CITY OF FORT PIERCE

Agenda Item 7A

531 N 2nd Street

Replacement of original windows with PGT vinyl, impact windows.

Window Type & Design Proposed

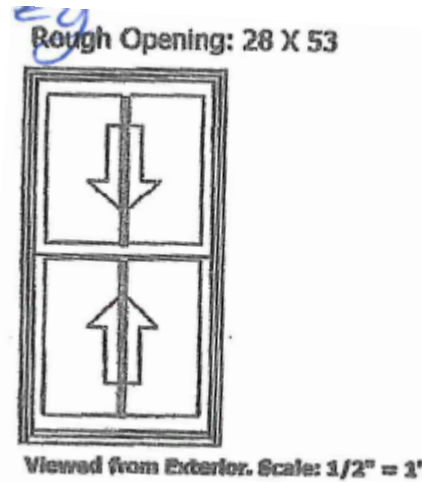
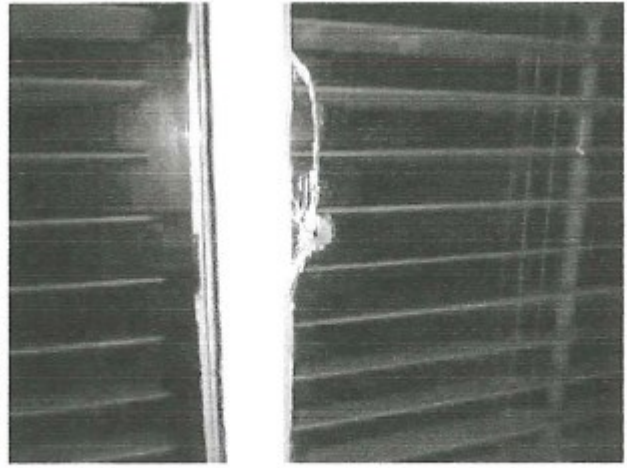
The proposed replacement of all remaining original wood windows is not consistent with Secretary of Interior Standards 2 & 5, however the condition of the windows, as presented by the applicant, substantiates a need for action to address current damage. The majority of the original windows presented appear to be eligible for preservation and restoration, where possible. If the Board deems the features are deteriorated beyond feasible repair, replacement windows shall match the old in design, color, texture, and other visual qualities and, where possible, materials. Staff urges that if window replacement is granted, based on the condition of the windows, that the applicant exhaust efforts to restore the original windows on the front façade with any salvageable windows present on the structure (of the same design, style, etc.), and utilize a wood, or wood cladded, impact window as the replacement option, for unsalvageable windows. Replacement of windows shall be substantiated by documentary, physical, or pictorial evidence.

Model: DH5560 PVC Impact Equal Leg Double Hung
 Operator Type: H
 Config: All, GS-5/16" Ann Lami IG

Staff recommends approval of the requested window replacement with the condition that the applicant exhaust efforts to restore the original windows on the front façade with any salvageable windows present on the structure (of the same design, style, etc.), and utilize a wood, or wood cladded, impact window as the replacement option to ensure compliance with Secretary of Interior Standards 2, 5, & 6.

Existing Window Condition—Presented by Applicant

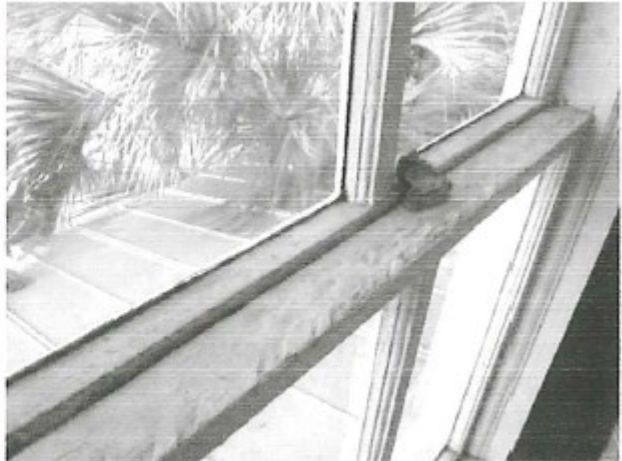
**Original Window Design
to be replaced with replica
Double Hung with split design**

Broken Glass

**Rotted Sills with gaps
Not able to repair again**

**Broken Glass
Top Panes are fixed in place
existing double hung does not work**

**Windows do not seal
with increased energy costs**
